City of Aurora Building Division
Project: *Plan Revisions to RSN 1652119*
Address: *1400 South Potomac Street Unit 250*
Occupancy Group: *IBC B*
Construction Type: *UBC II-N-SPK*
RSN: *1672715*
Permit: *22-2243719-LT*

City of Aurora Building Division
Reviewed for Code Compliance
Approved as Noted: *Bobby McKinzie*
Date: *Nov 13, 2022*
2015 INTERNATIONAL CODES & 2020 NEC

Sundermeyer Family Practice
1400 S. Potomac, Suite 250
Aurora, CO 80012

Sheet Title:
LEVELS ONE AND TWO - OVERALL POWER PLANS

1 / E-001 EXISTING PARTIAL ELECTRICAL ONE-LINE DIAGRAM

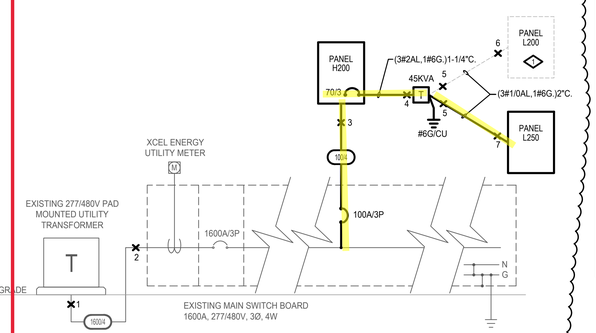
Install electrical connections per 2020 NEC 110.14, Identify disconnects per 2020 NEC 110.22 and provide working space around Electrical equipment per 2020 NEC 110.26

Provide a Grounding Electrode System bonded To the service equipment enclosure, grounded Conductors, and grounded electrode conductors Per 2020 NEC 250.50 and 250.104

Every circuit and circuit modification shall be legibly Identified as to it's clear, evident and specific purpose or use. The identification shall include an approved degree of detail that allows each circuit to be distinguished from all others. 2020 NEC 408.4

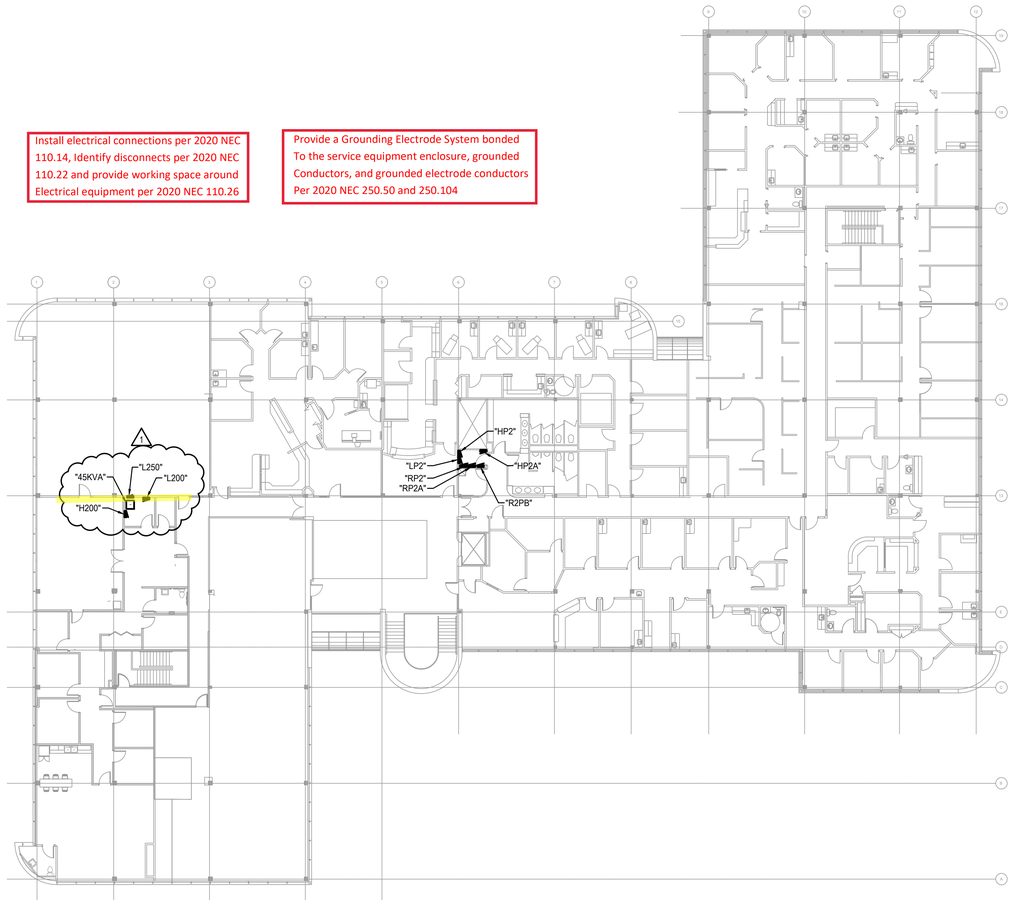
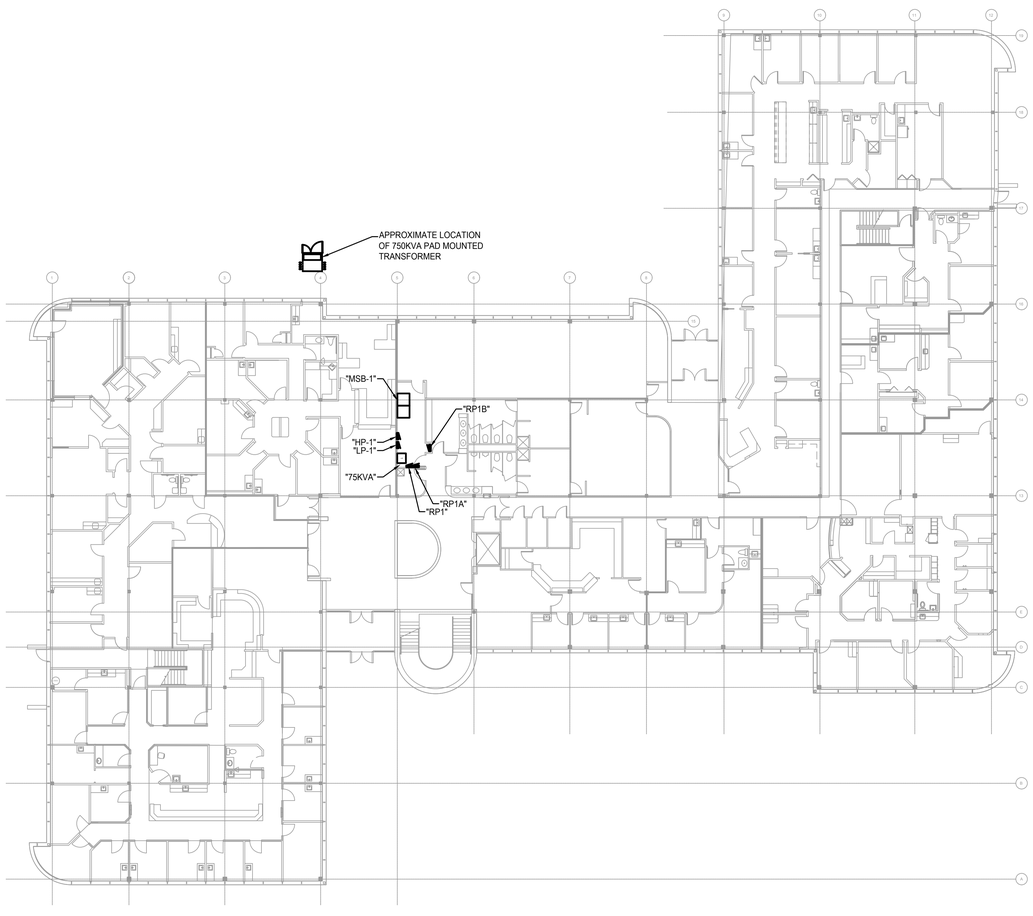
Install electrical connections per 2020 NEC 110.14, Identify disconnects per 2020 NEC 110.22 and provide working space around Electrical equipment per 2020 NEC 110.26

Provide a Grounding Electrode System bonded To the service equipment enclosure, grounded Conductors, and grounded electrode conductors Per 2020 NEC 250.50 and 250.104

Sheet Title:
LEVEL TWO - POWER PLANS - NEW AND DEMO

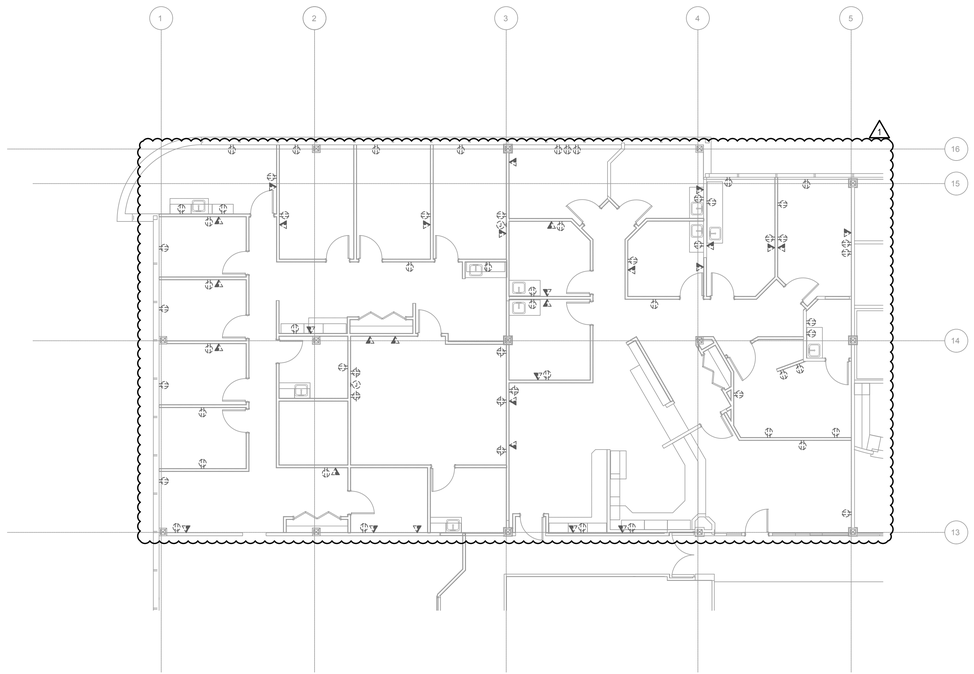
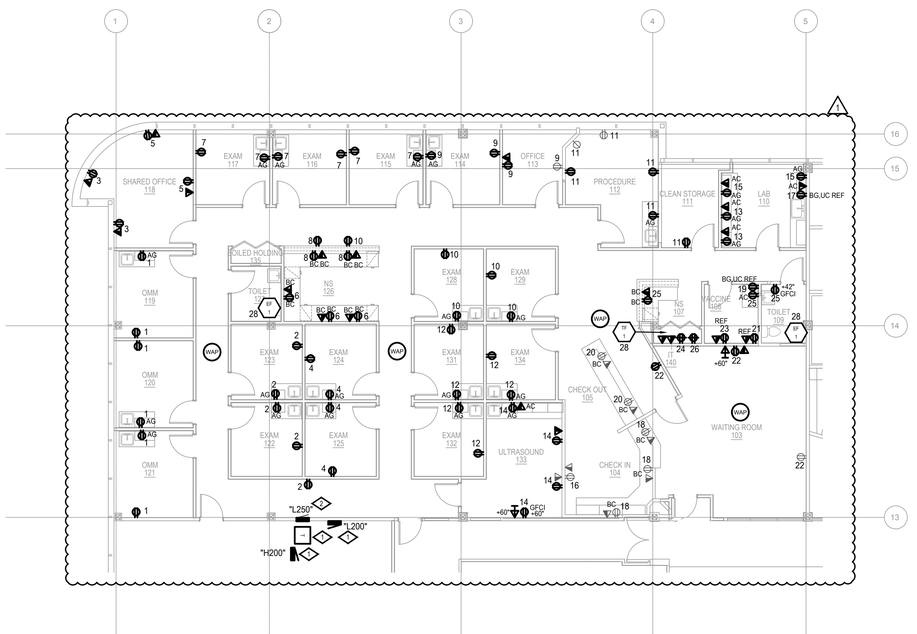
THIS SHEET OF DRAWINGS HAS NOT BEEN REVIEWED FOR CODE COMPLIANCE.
